**PREPARED FOR THE PLAN COMMISSION**

Project Address: 10024 Valley View Road
Application Type: Zoning Map Amendment, Preliminary Plat, and Demolition Permit
Legistar File ID # [54248](#), [54018](#) and [54456](#)
Prepared By: Timothy M. Parks, Planning Division
Report includes comments from other City agencies, as noted

Pioneer NDP – 2018 Update; Land Use and Street Plan (Map 7)

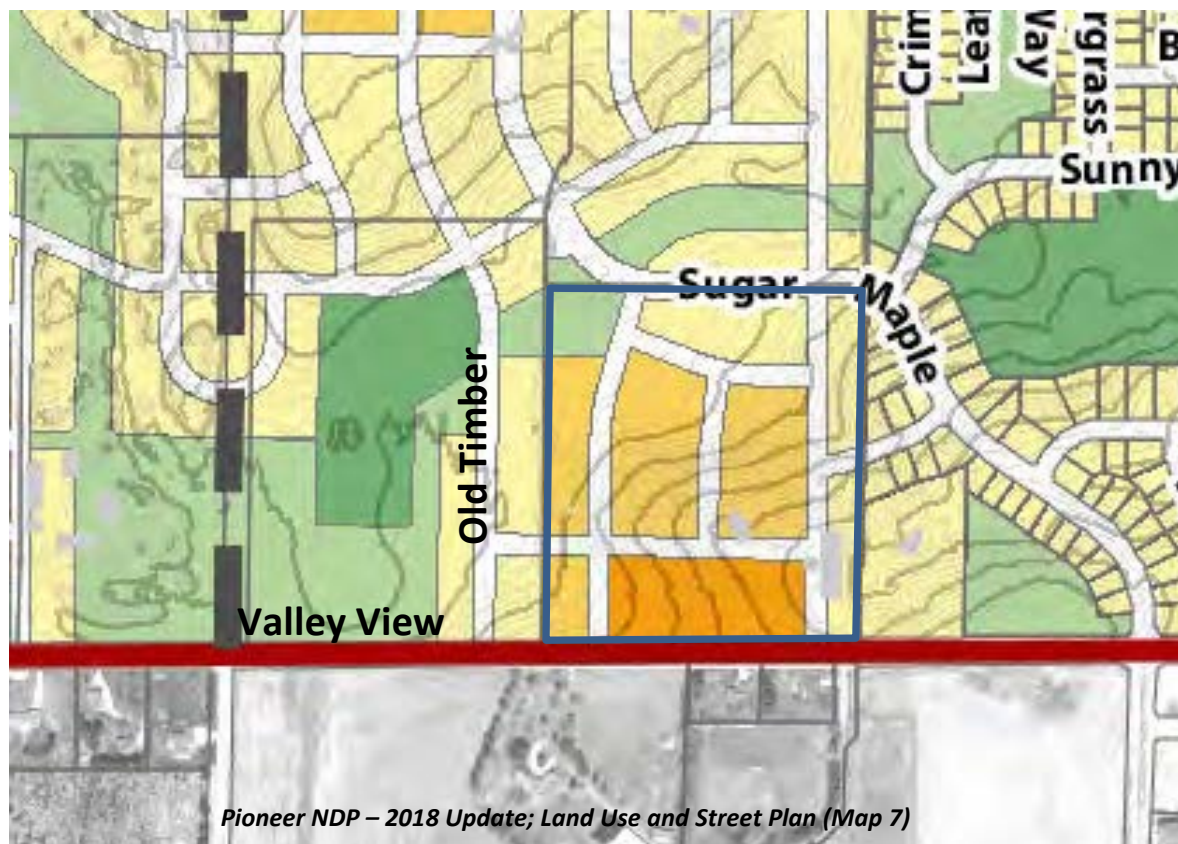
Staff also believes that the layout of the subdivision is largely consistent with the street layout included in the Pioneer Neighborhood Development Plan, although how Sugar Maple Lane will be implemented with this plat should be given careful consideration.

Since initial adoption in 2004, the Pioneer plan has recommended that Sugar Maple Lane extend from Valley View Road to Mineral Point Road approximately halfway between South Point Road and Pioneer Road as a north-south collector street to serve the mostly residential development planned for that portion of the planning area. In general, implementation of Sugar Maple Lane with the 1000 Oaks, Birchwood Point, and Southern Addition to Birchwood Point subdivisions has followed the 2004-planned alignment with modest deviation.

The 2018 update to the Pioneer Neighborhood Development Plan provides a more detailed alignment through the subject site, calling for Sugar Maple Lane to connect through the Reynolds property and adjacent May-Moore property along their common east-west property line (i.e. northern edge of subject site), with HM1 residential development on both sides of the street. However, the applicant proposes to shift the east-west segment and abutting lots south entirely onto the Reynolds property, which will leave an approximately 300-foot section of the collector street unbuilt until the connection can be made across the May-Moore property at some unknown time in the future.

Although staff from the Planning Division and City Engineering Division believe that the proposed alignment can be approved, staff feels that the planned north-south collector street be completed with the platting of the proposed subdivision, and are requiring that the remaining section of Sugar Maple Lane adjacent to the northwestern corner of the Reynolds property be acquired, dedicated and constructed as a condition of approval. Completing the collector street now will allow for a complete street network to serve this portion of the Pioneer neighborhood and will prevent local streets such as Old Timber Pass, which staff does not believe is intended to carry the volume of a collector street, from shouldering that load until Sugar Maple can be completed as planned.

The connection of Sugar Maple Lane is also important to provide the overall level of connectivity that the neighborhood plan recommended in this area, including an additional north-south local street that was planned to extend between Valley View Road and Watts Road through the Reynolds and May-Moore properties. That north-south street would have required a crossing of the significant greenway planned to drain east to west towards the large stormwater management facility planned for proposed Outlot 19 in the southwestern corner of the subject site. However, staff feels that the off-site completion of Sugar Maple Lane in conjunction with the east-west street connection added through the pending 1000 Oaks Replat No. 1 will accomplish the circulation and connectivity goals of the Pioneer Neighborhood Development Plan in lieu of the planned north-south street.
